CITY of NOVI CITY COUNCIL

Agenda Item 2
October 12, 2009

Novi Town Center Building G Demo and Reconstruction SP 09-22

SP #09-22

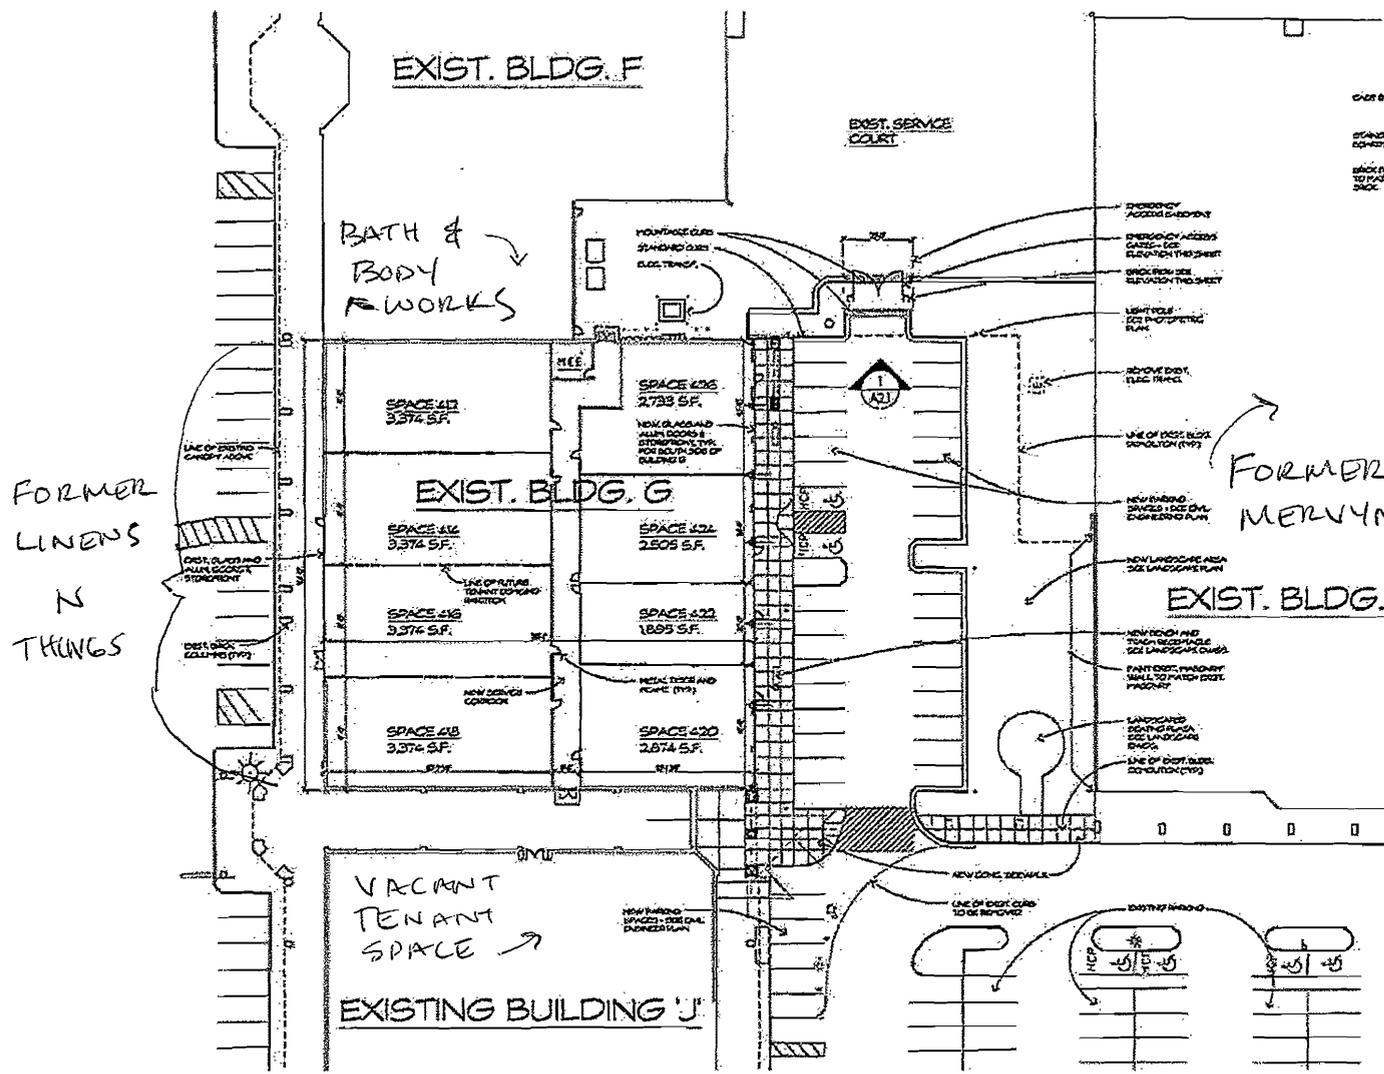
2. The applicant is proposing to install a gate at the east end of the new parking lot to allow emergency pass-through for fire apparatus. The proposed access drive is planned to be grass pavers. The proposed design does not meet the minimum requirements of the Design and Construction Standards, Section 11-197(a)(19), for the design of the gate (see Figure VII-K), width of the access drive, and load carrying capacity of the brick pavers. Additional details shall be provided for the construction of the gate and corrections made to the design to meet the minimum standards.

The above plan is **NOT RECOMMENDED** for **APPROVAL** due to the above deficiencies.

ELEVATION EMERGENCY ACCESS GATES

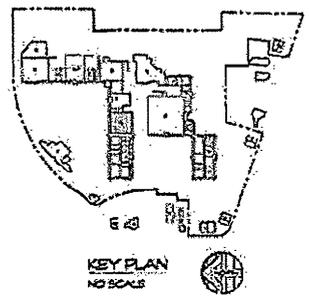
**SUPPLEMENTAL PLAN TO
ADDRESS FIRE MARSHALL'S CONCERNS**
